UNITED STATES PATENT AND TRADEMARK OFFICE

10/562,260

Ivo Agner

| Office Action Summary | Application No. 10/562,260 | Applicant(s) AGNER, IVO | |

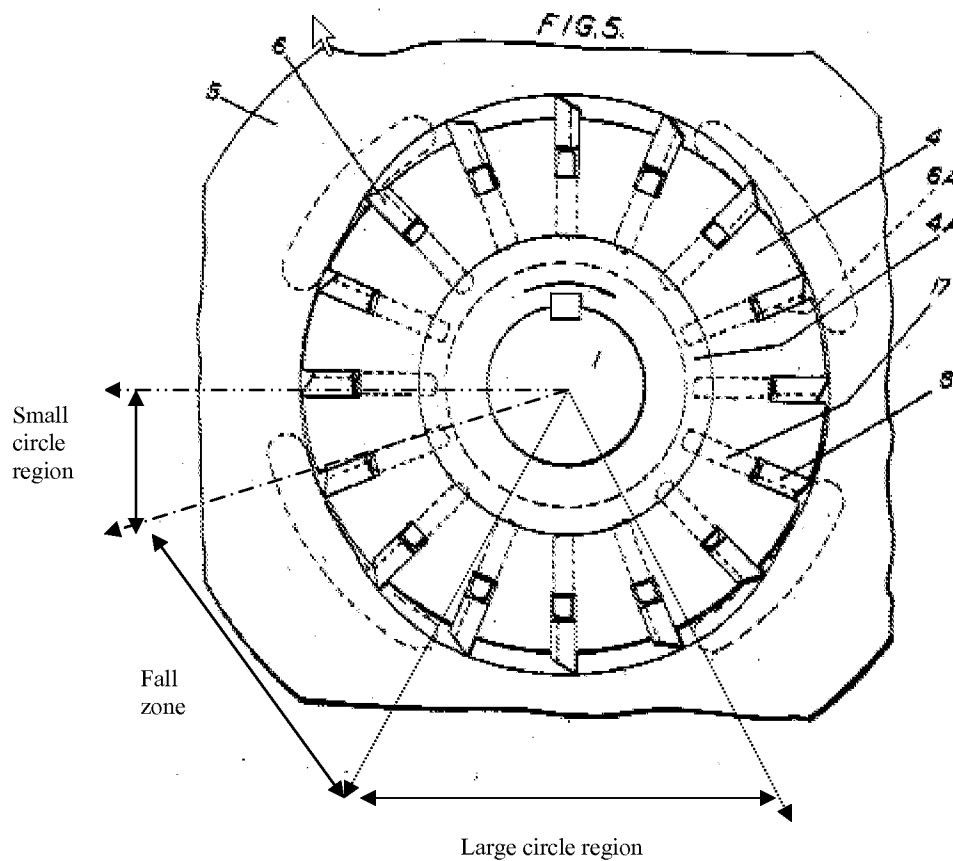
1. Claims 5, 6, 11 and 15 are rejected under 35 U.S.C. 102(b) as being anticipated by Prendergast (Patent Number 2,731,919).

Regarding claims 5, 6, 11 and 15, as shown in Figs. 5-6, Prendergast discloses a pump comprising: a double-stroke delivery contour, the delivery contour having at least one rise zone, at least one large circle region (see annotated Fig. 5 below), at least one fall zone (see annotated Fig. 5 below), and at least one small circle region (see annotated Fig. 5 below), and, a rotor 4 within the delivery contour, the rotor having radially displaceable vanes 6 in radial rotor slots, an angular range of the large circle region of the delivery contour being lengthened wherein the large circle region is greater than to the fall zone (see annotated Figs. 5-6- it is deemed inherent that the large circle region is greater than the fall zone); the pump is a transmission pump; a length of a suction region is not lengthened; wherein turning points of a displacement contour function are not spaced evenly about the delivery contour.
